**Re: Professional Engineering Opinions
Roxul RAN-5 Facility
WV/NPDES Multi-Sector Stormwater General Permit
Ranson, Jefferson County, West Virginia
Langan Project Number: 270112301**

Opinion 1 – The WV DEP disregarded their own policies, regulations, and best practices as they relate to the management and treatment of stormwater runoff from the RAN-5 Facility.

Opinion 2 – The WV DEP reviewed and approved the RAN-5 Facility's SWPPP and GPP without adequate supporting information to conclude that the measures of these plans protect the environment.

Inset from The SWPPP Figure 2A

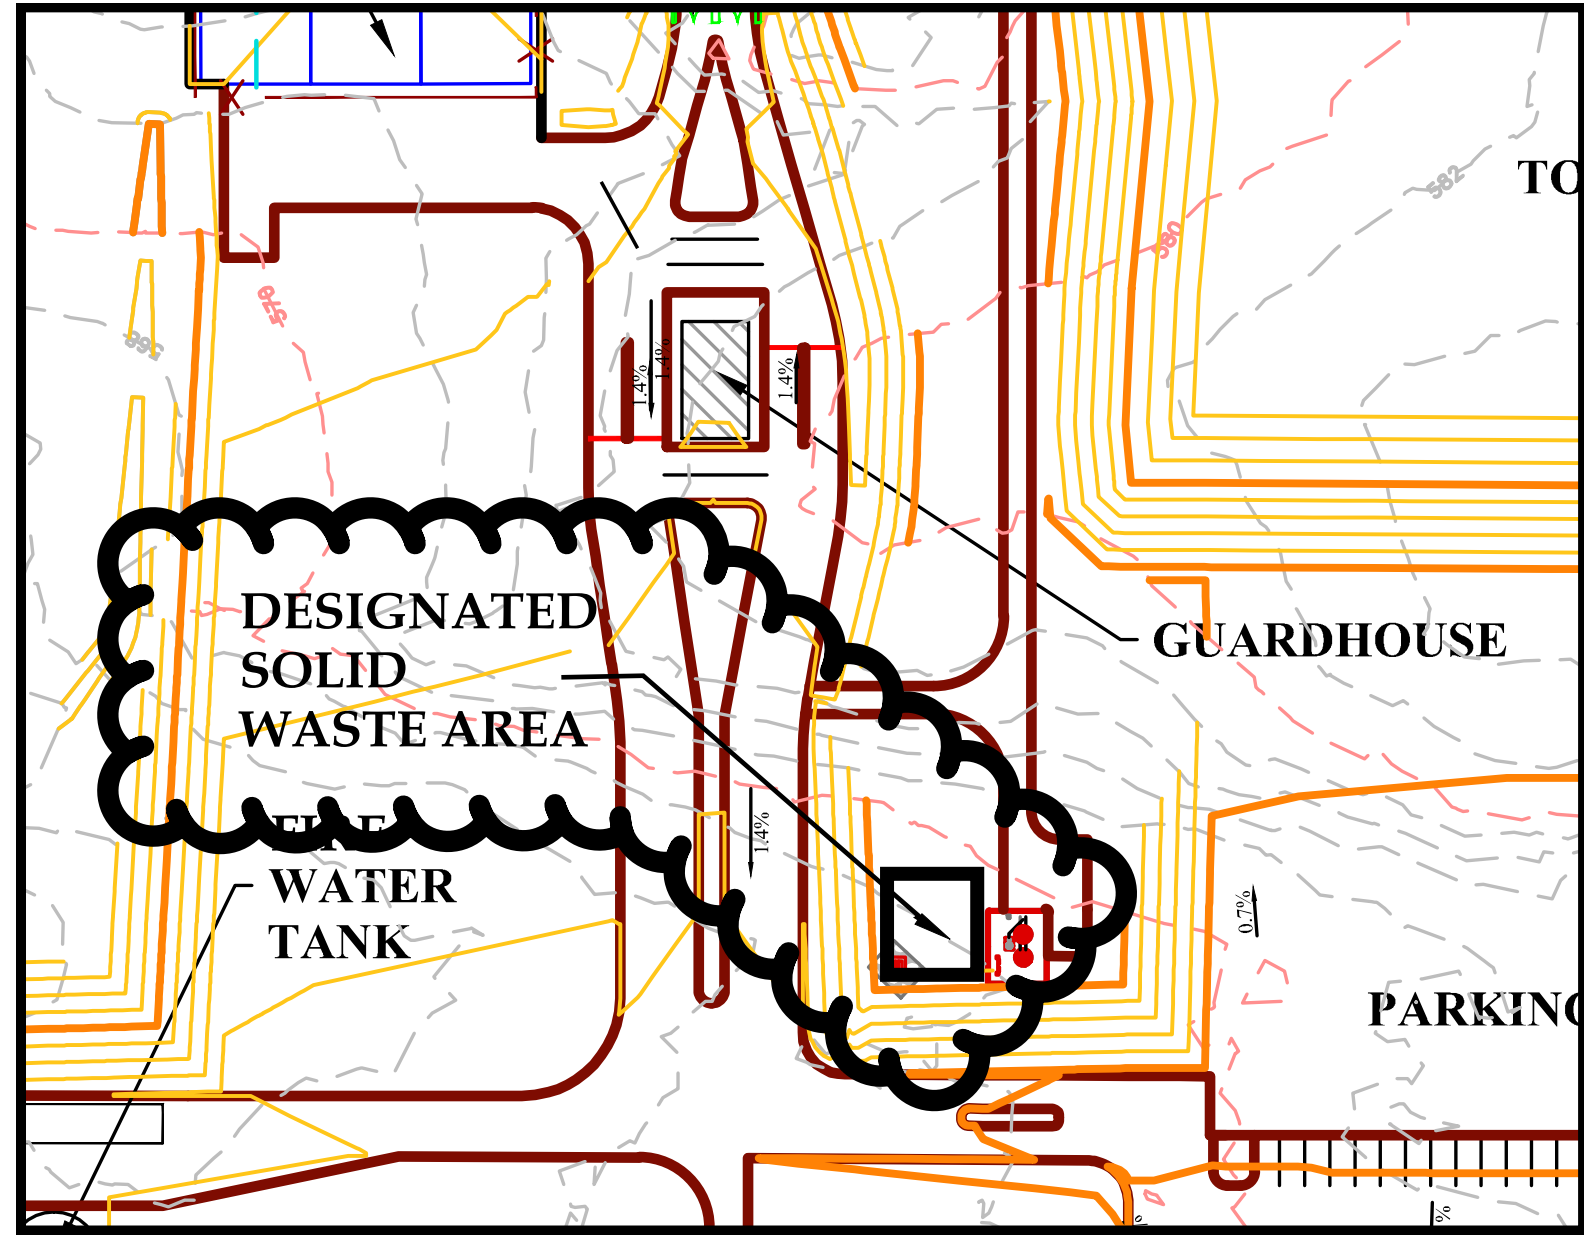
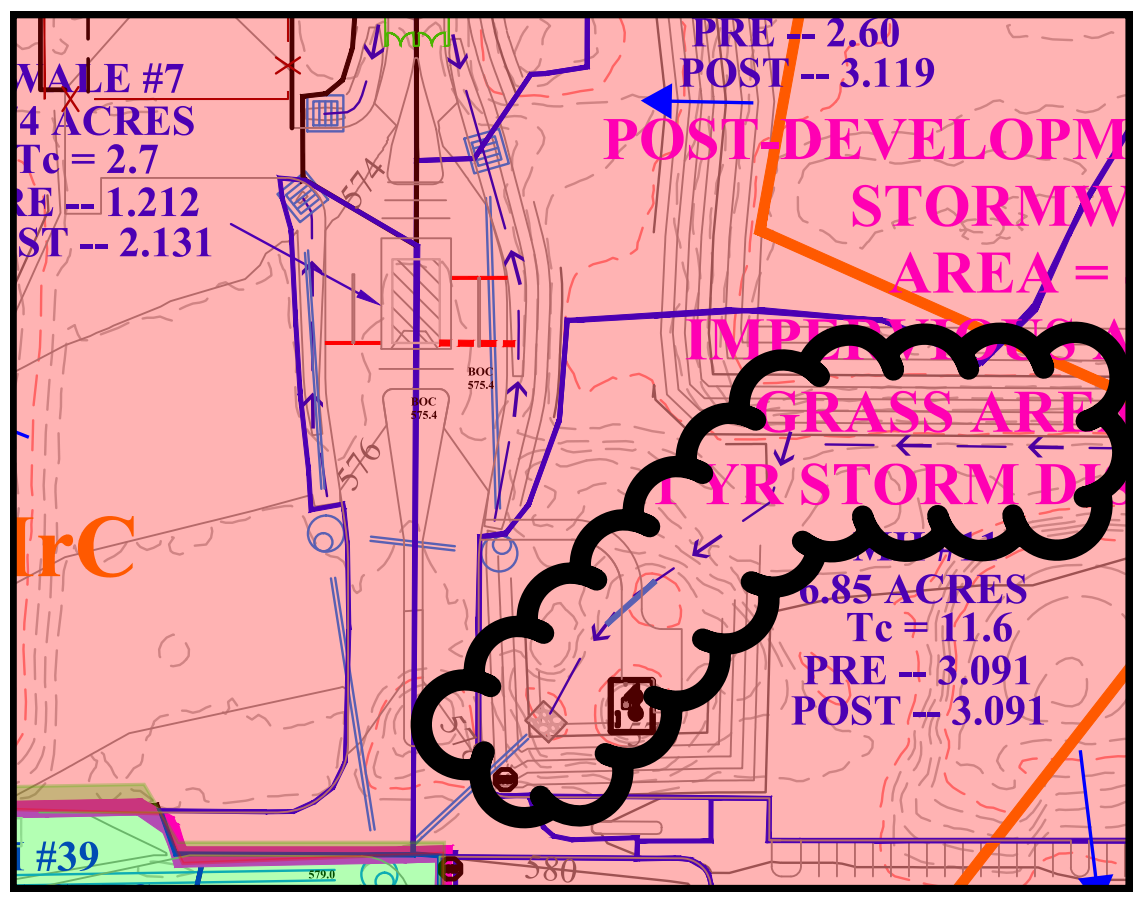
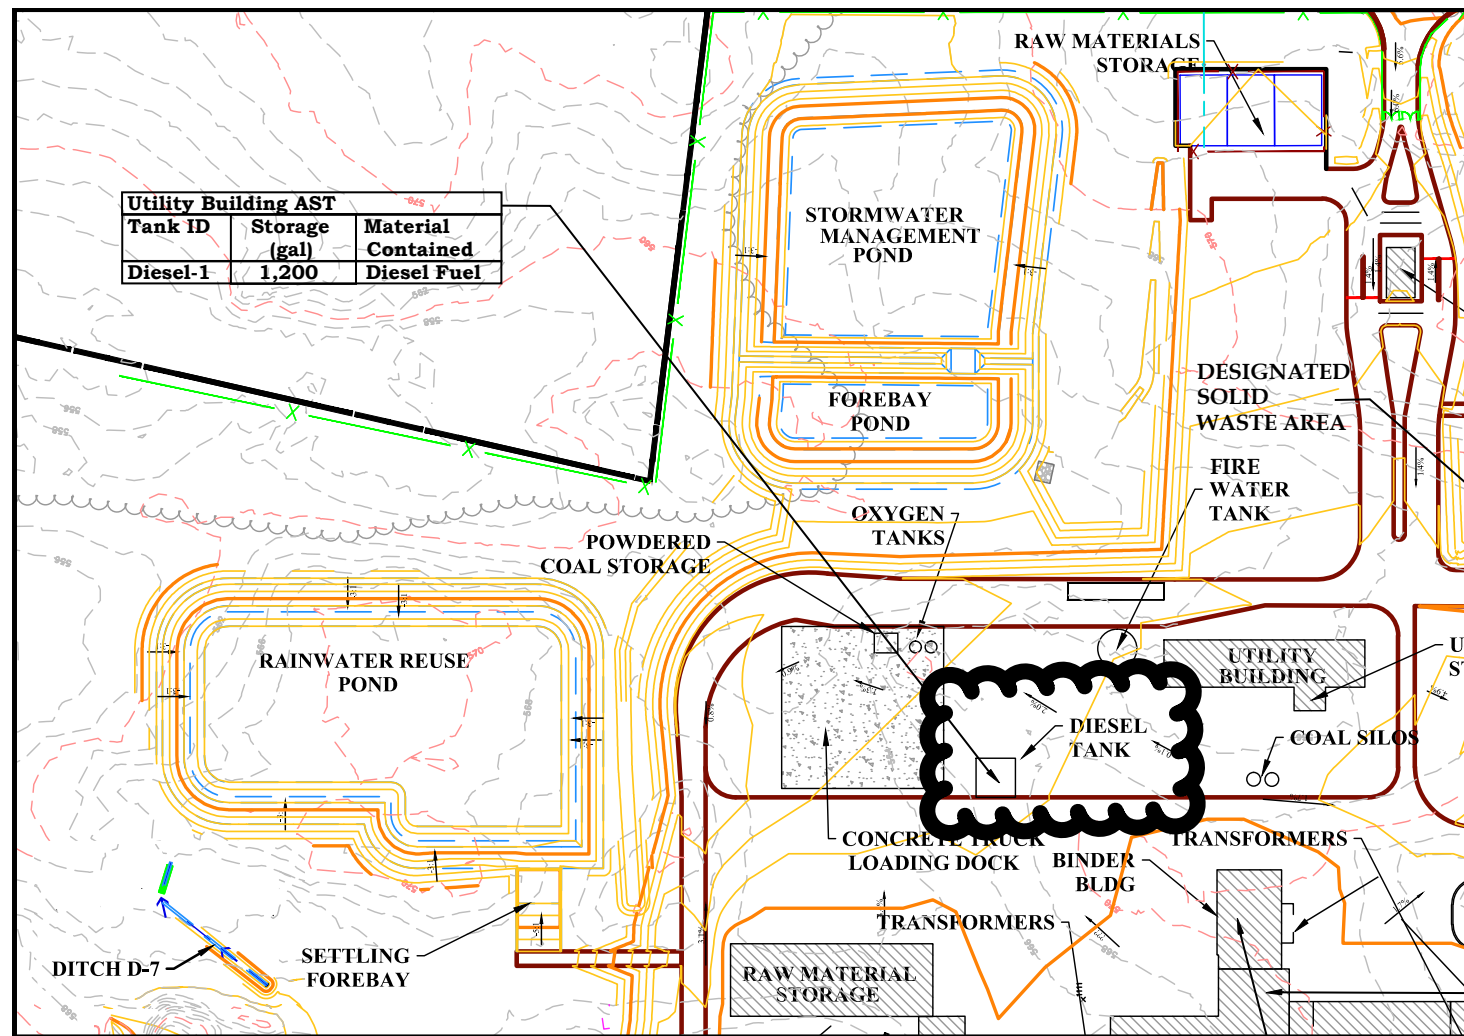
For example, in Figure 2A and Figure 3, at the southeast corner intersection where the main entrance drive meets the internal site access road, a stormwater drainage swale and inlet with a piped connection that discharges runoff to the site's stormwater management pond is shown. However, in Figure 2B, a designated solid waste area is shown in this location directly over the inlet and the swale; see Exhibit 2A-1. Either the solid waste area needs to be moved to a location where it is not obstructing any stormwater systems, or the swale and inlet needs to be relocated. Regardless, all figures should be updated to consistently reflect the current and intended design.

Inset from The SWPPP Figure 2B

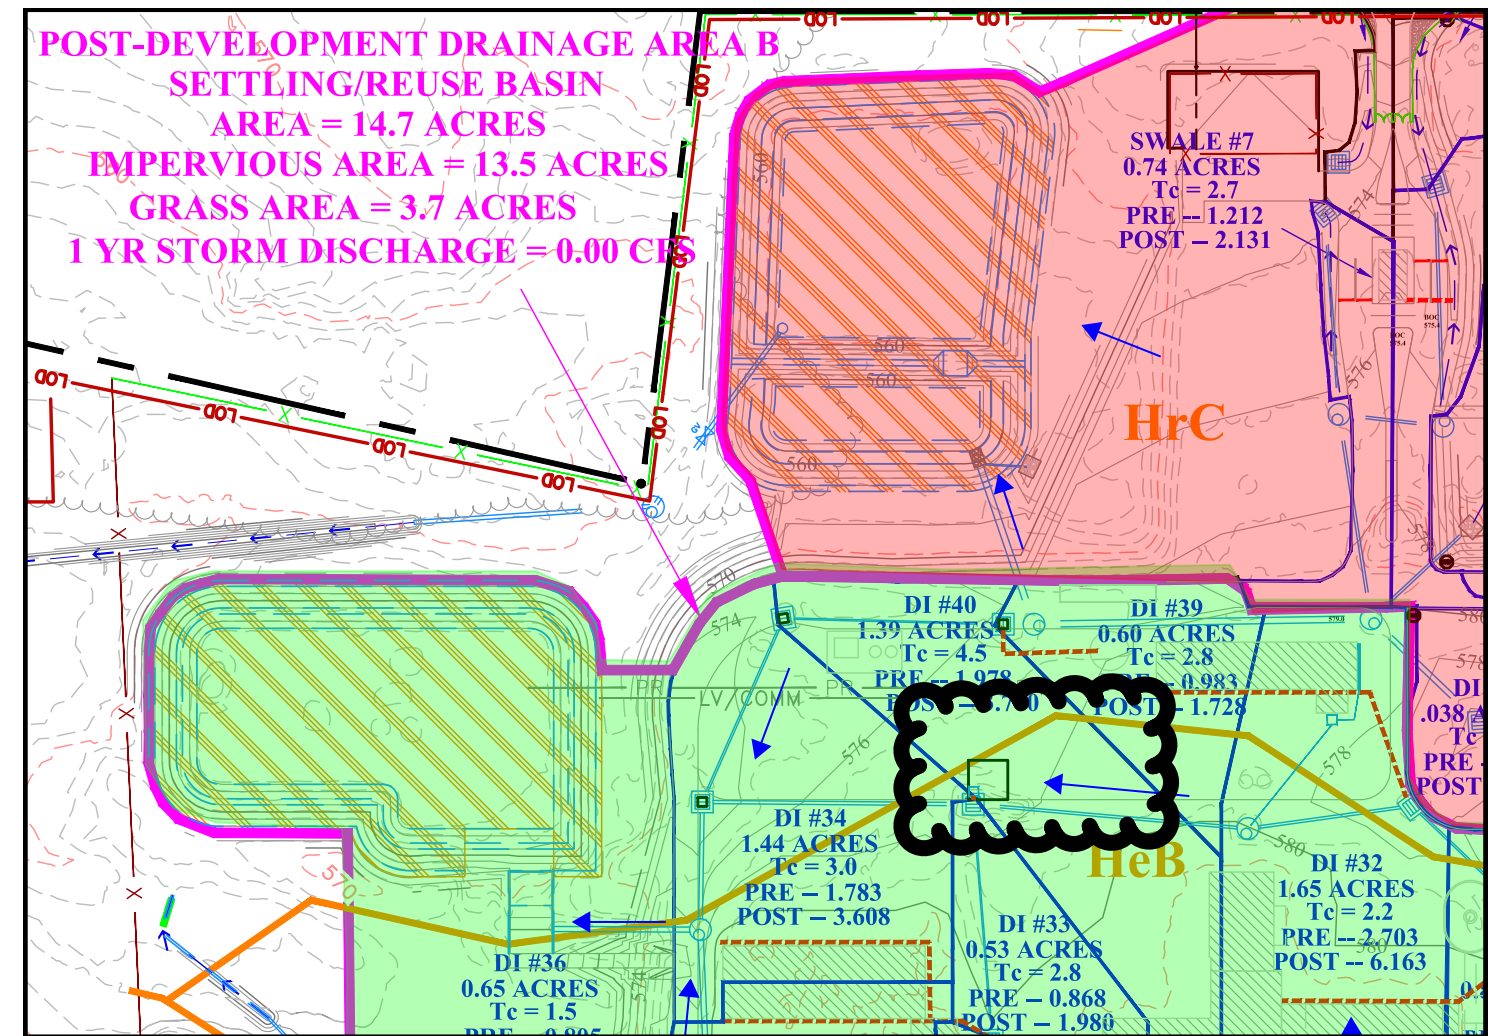
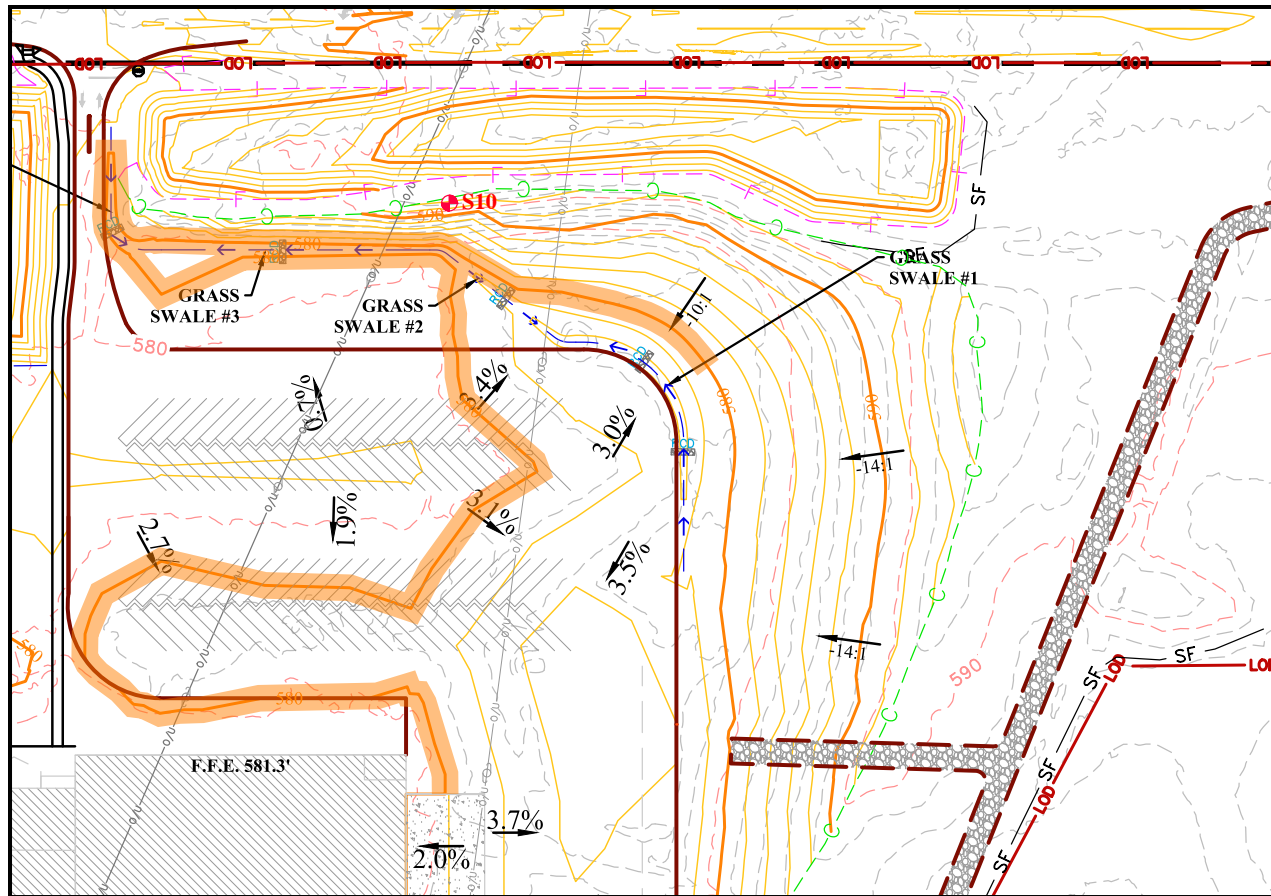
Another example of conflicting information is the diesel above ground storage tank (AST) shown northwest of the utility building and inbound of the site access road on Figure 2B. According to Figure 3, this tank is also located on top of drainage inlet #33; see Exhibit 2A-2. Further information on this AST could not be located in The SWPPP according to its "Diesel-1 1,200 gallon" identification. Either the AST needs to be moved to a location
